AGENDA
FARRAGUT MUNICIPAL PLANNING COMMISSION

January 19, 2017
7:00 p.m. Farragut Town Hall

Preliminary Subdivision Plat - Lot Layout
Easton Park
11739 Turkey Creek Road
Farragut, Tennessee
HFTC Partnership, GP

Preliminary Plat - Site Grading and Drainage Plan
N. Peterson Road Extension
Town of Farragut
N. Peterson Road
Farragut, Tennessee
JAN 10 2017

C4.0
SHEET 5 OF 10

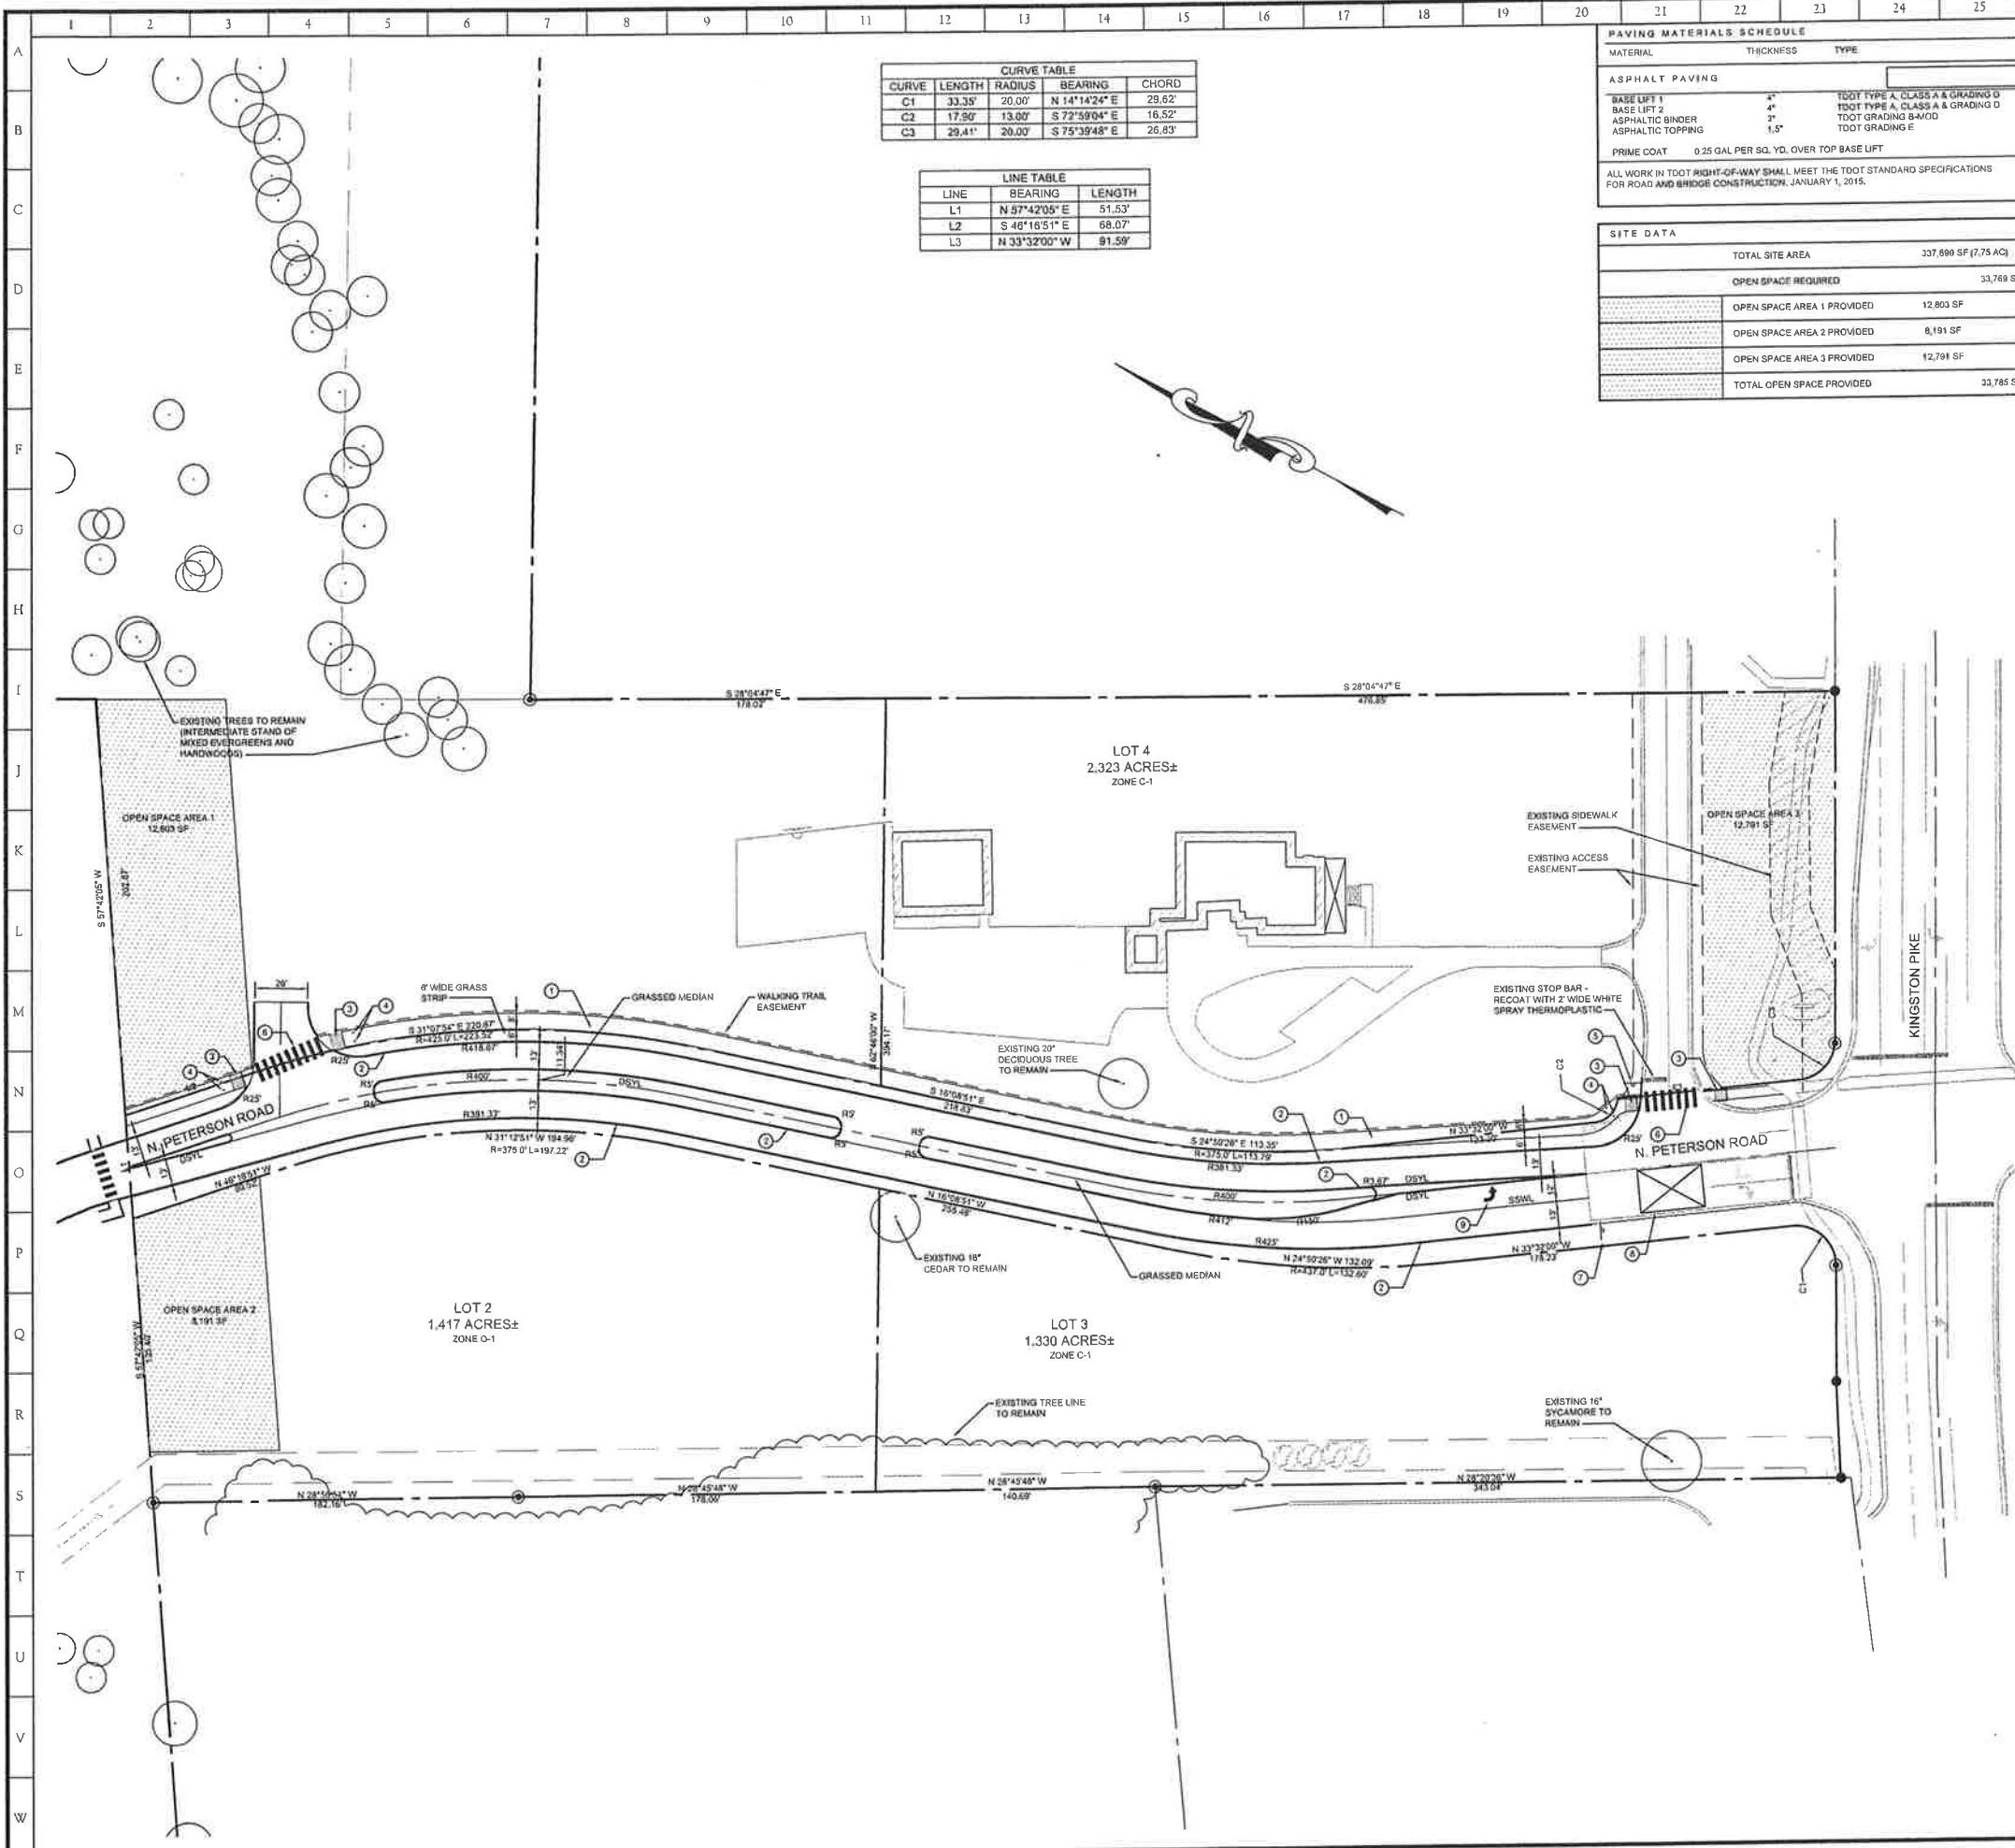
- 18) The Traffic Control plan continues to show stop sign on Peterson Road at Ingles' entrance. Has this been determined to be the best option by a traffic engineer?;

The sign shown is a "Do Not Block Intersection" sign. We have removed the stop bar. See sheet C4.0.

C2.2
SHEET 4 OF 36

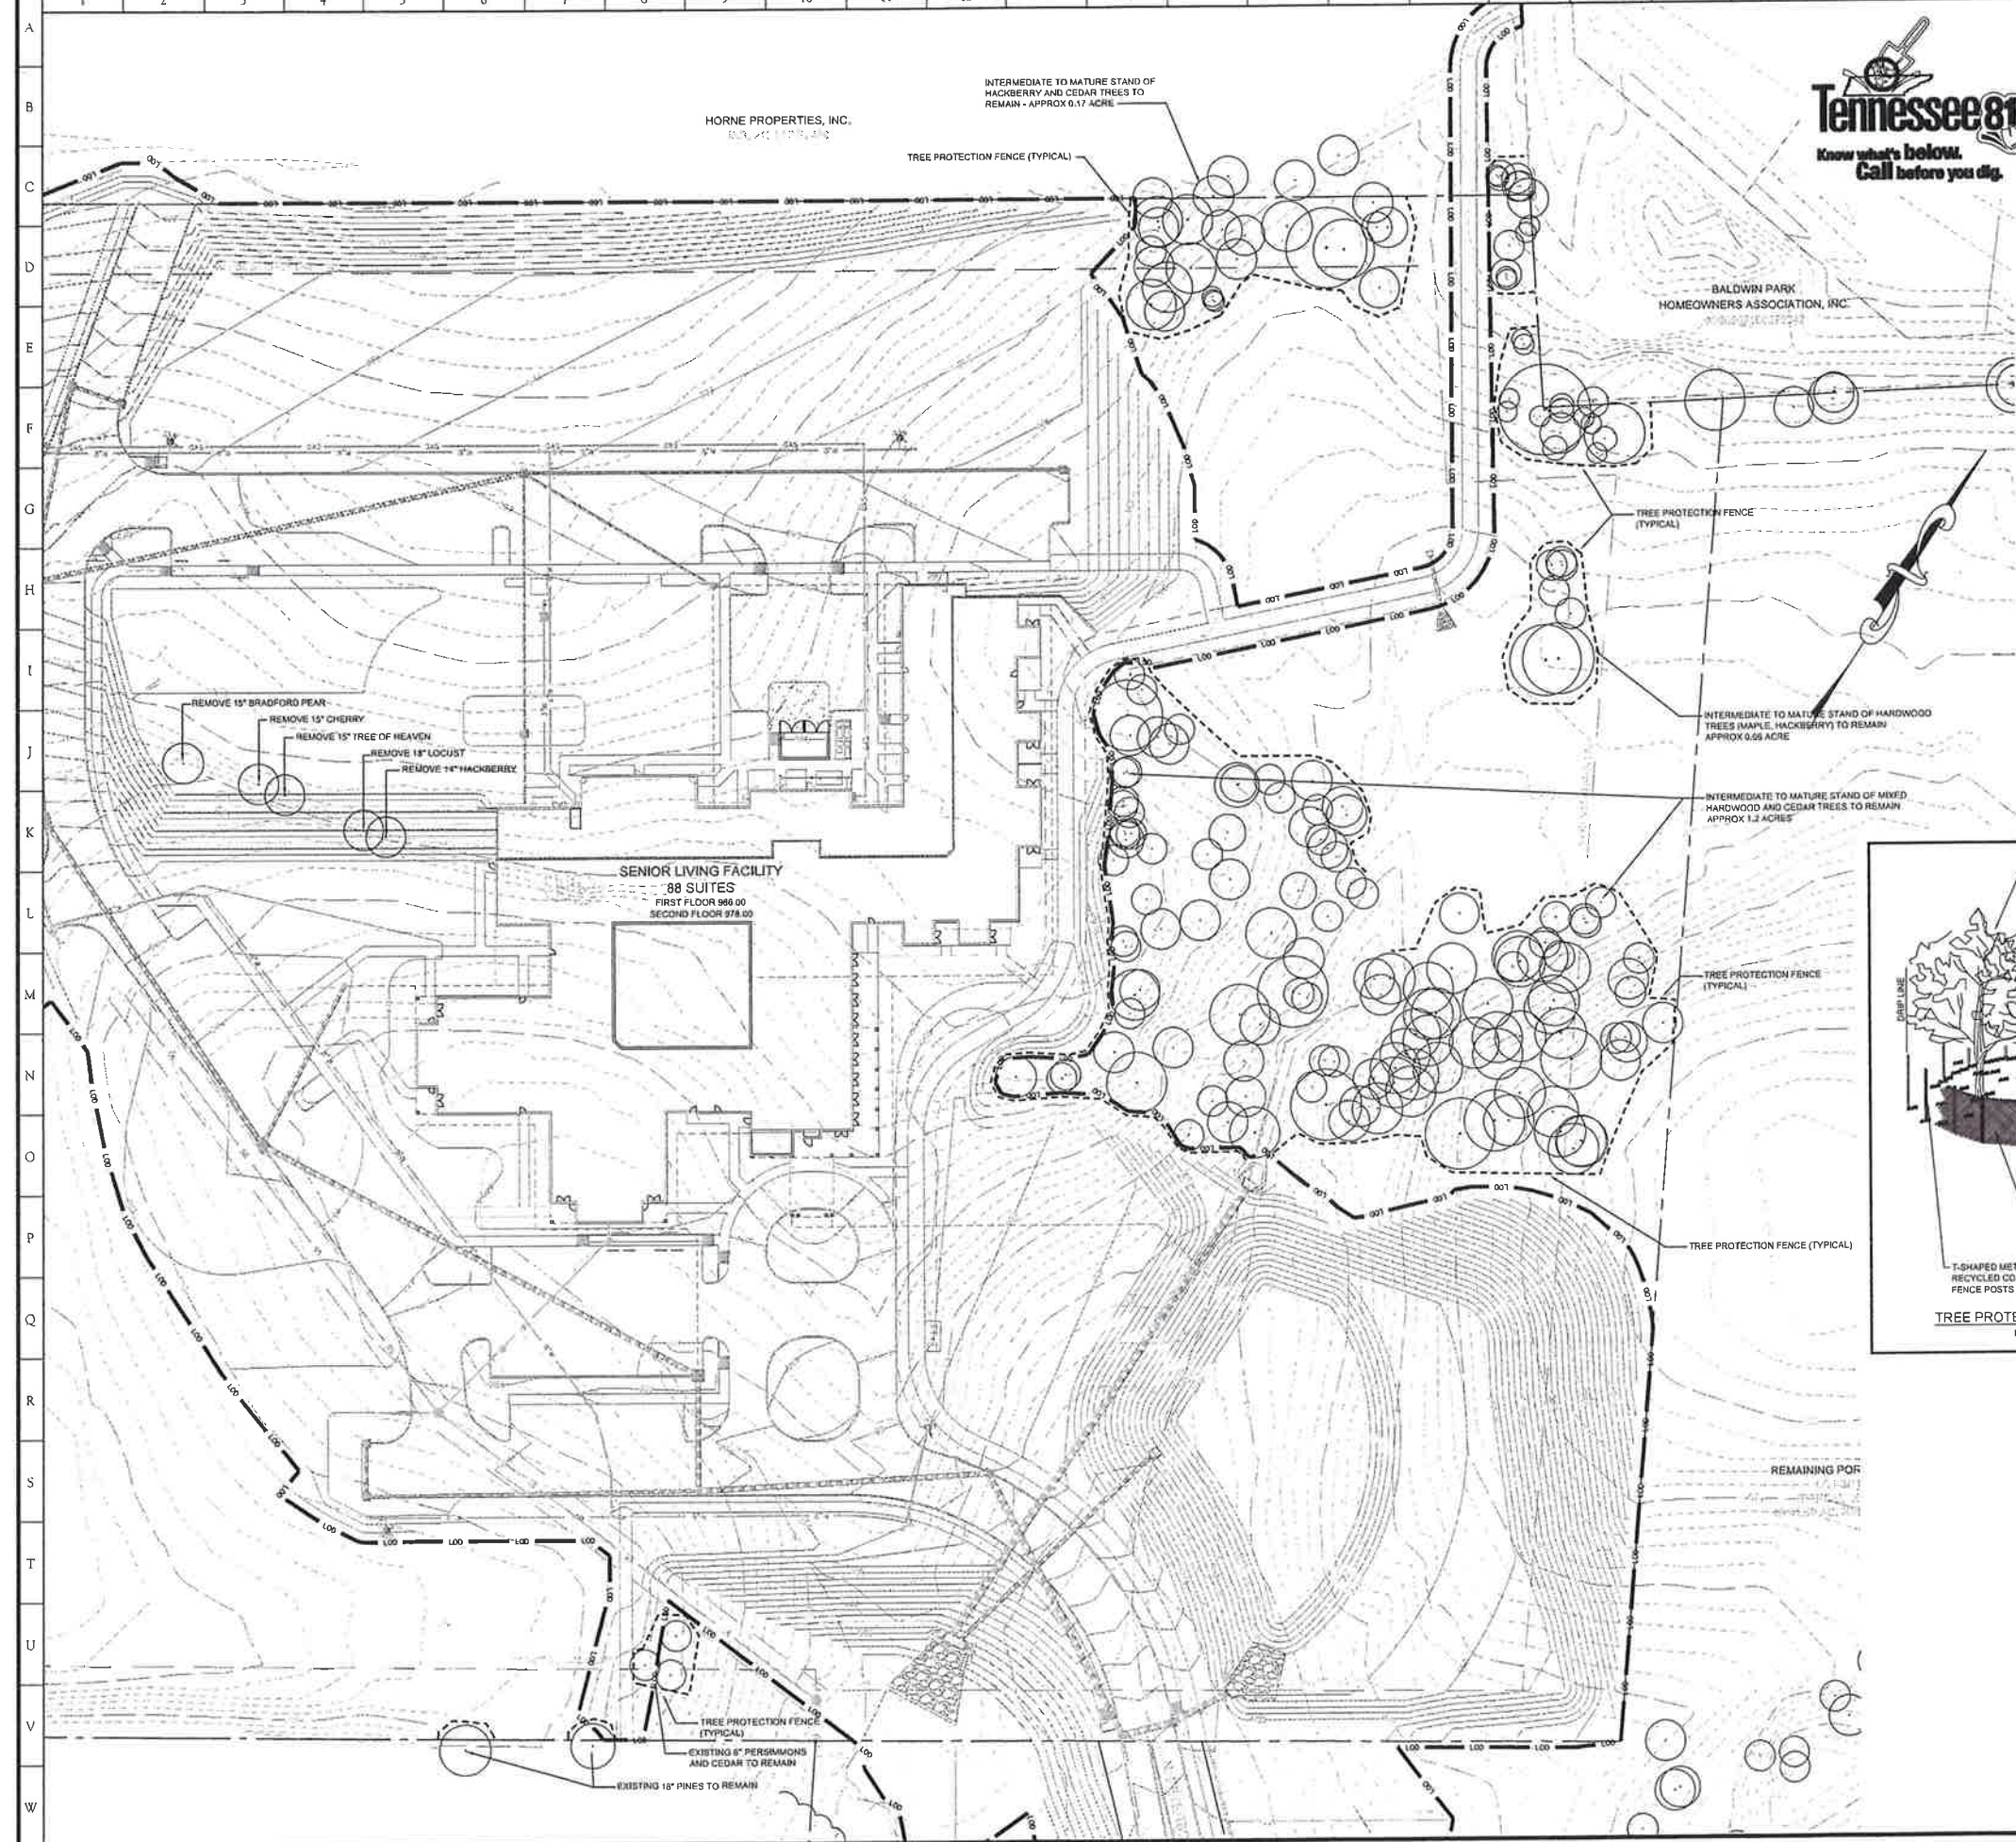
- 17) On sheet C2.1, please make sure the tree fencing is extended to the dripline in all areas;
Tree Preservation Plan has been renumbered to sheet C2.2. Fencing is extended to the driplines.

E1.0

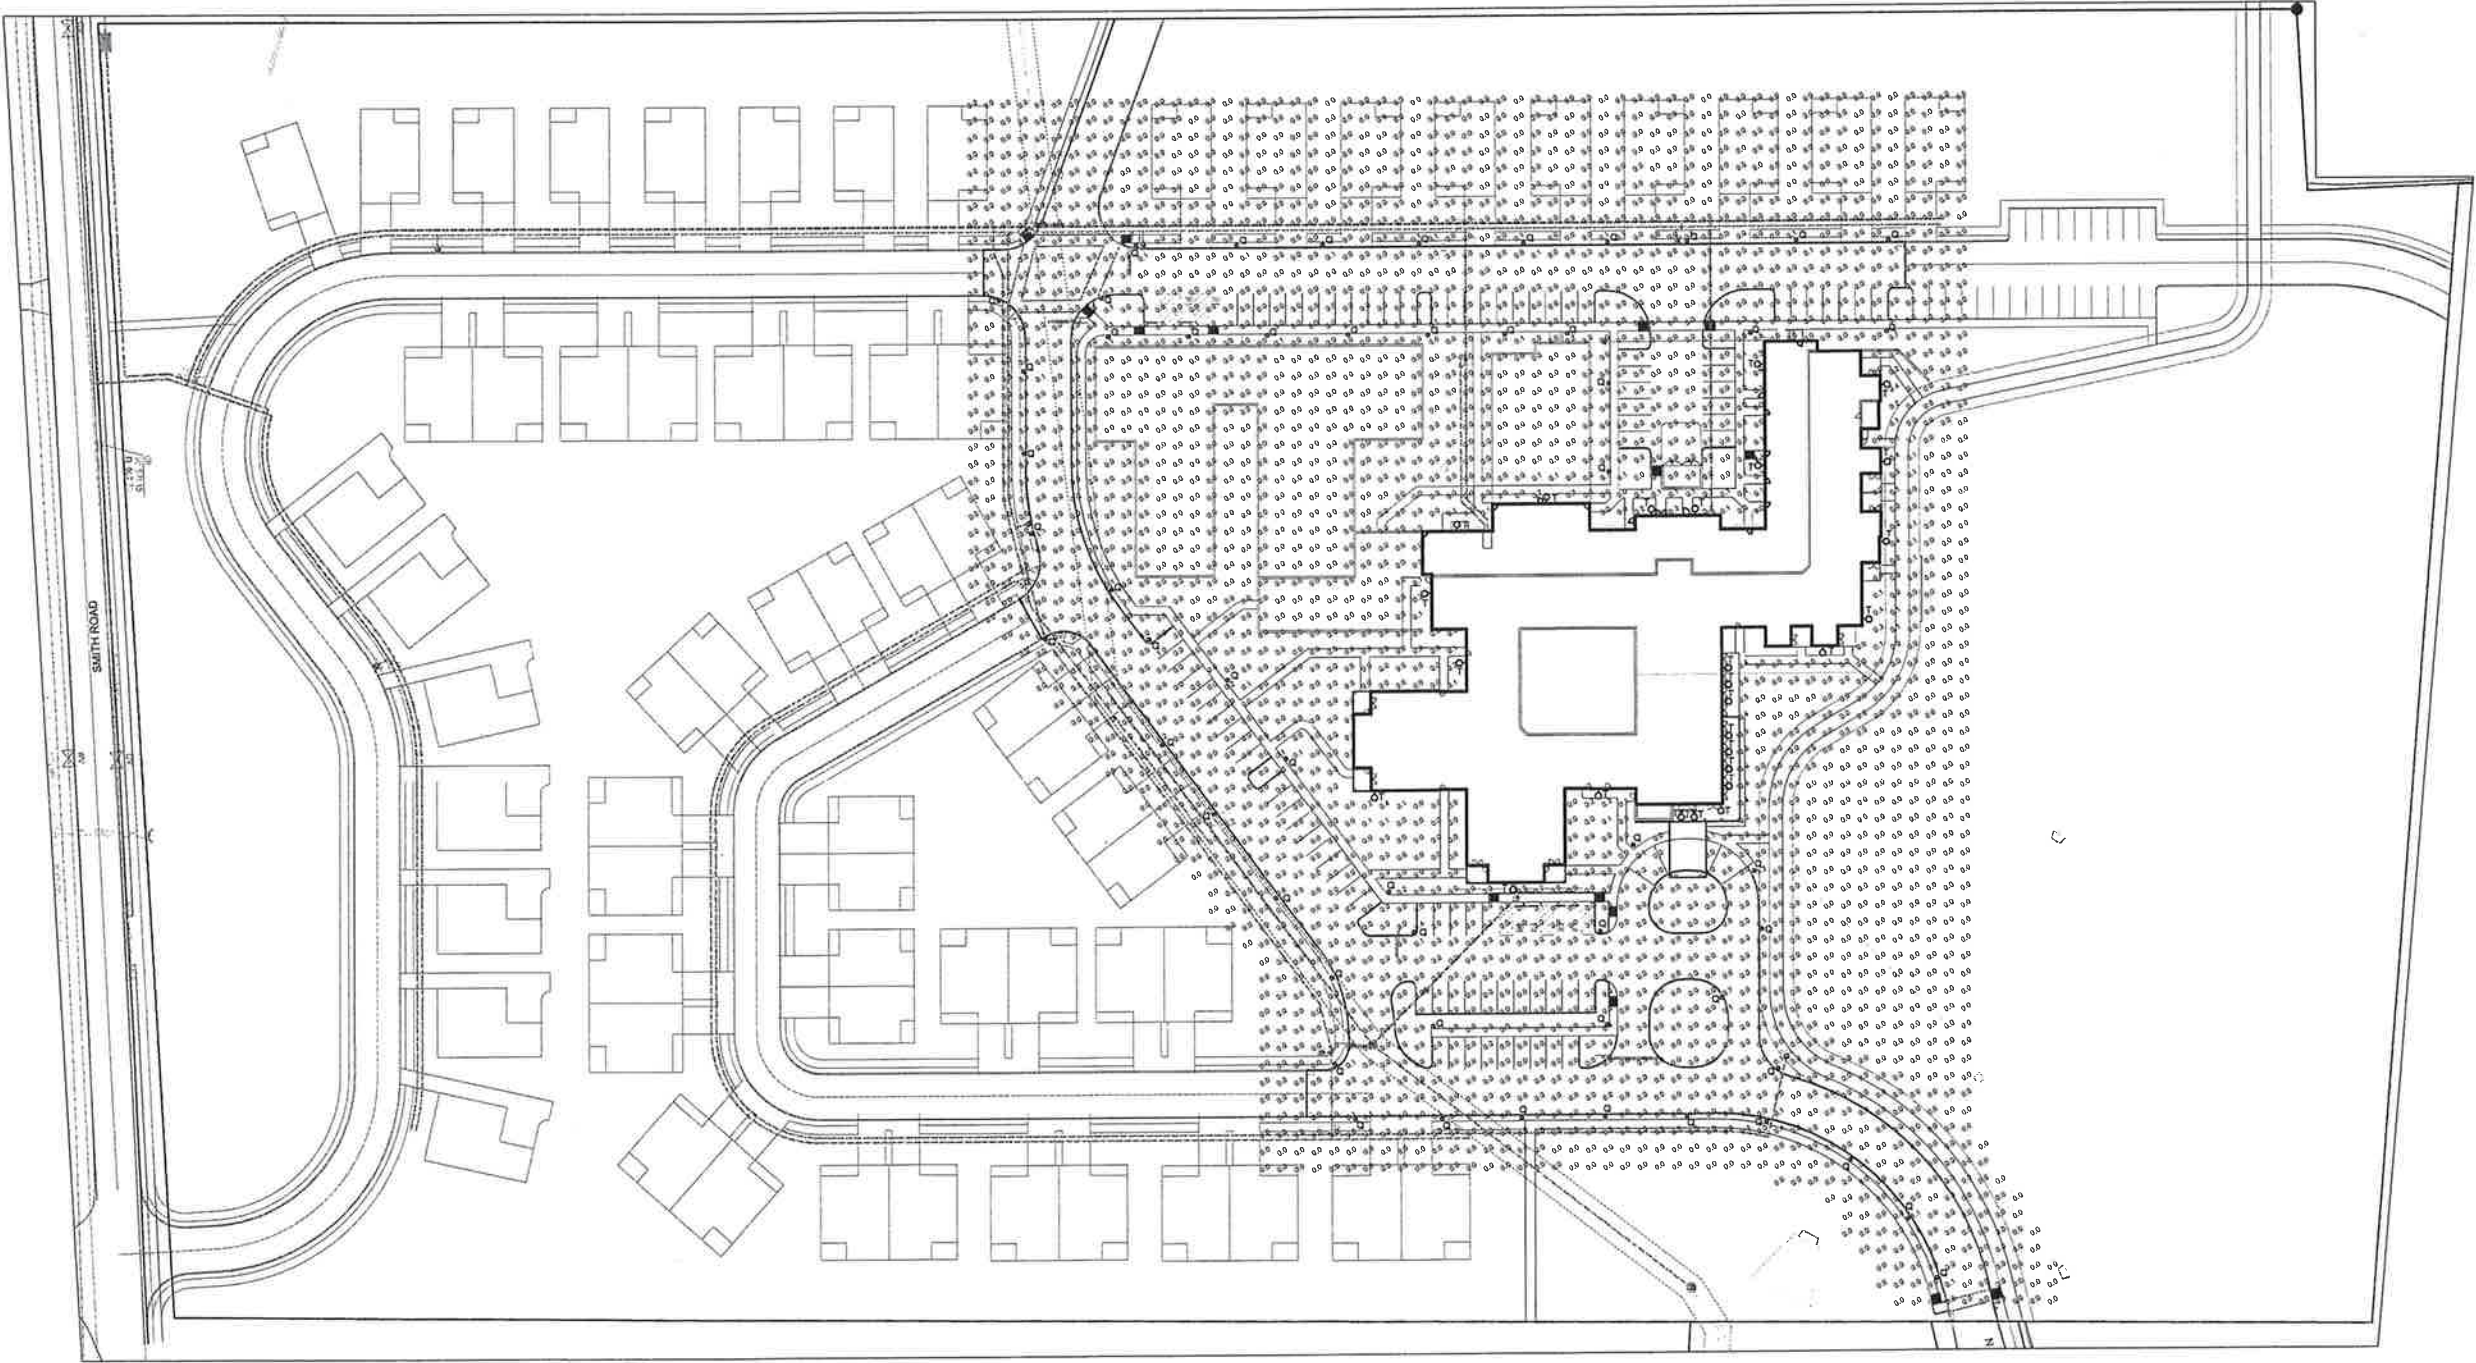
- 22) Please have the electrical engineer provide more detail related to the lenses for the proposed lighting fixtures;
A note regarding the lenses has been added to sheet E1.0.
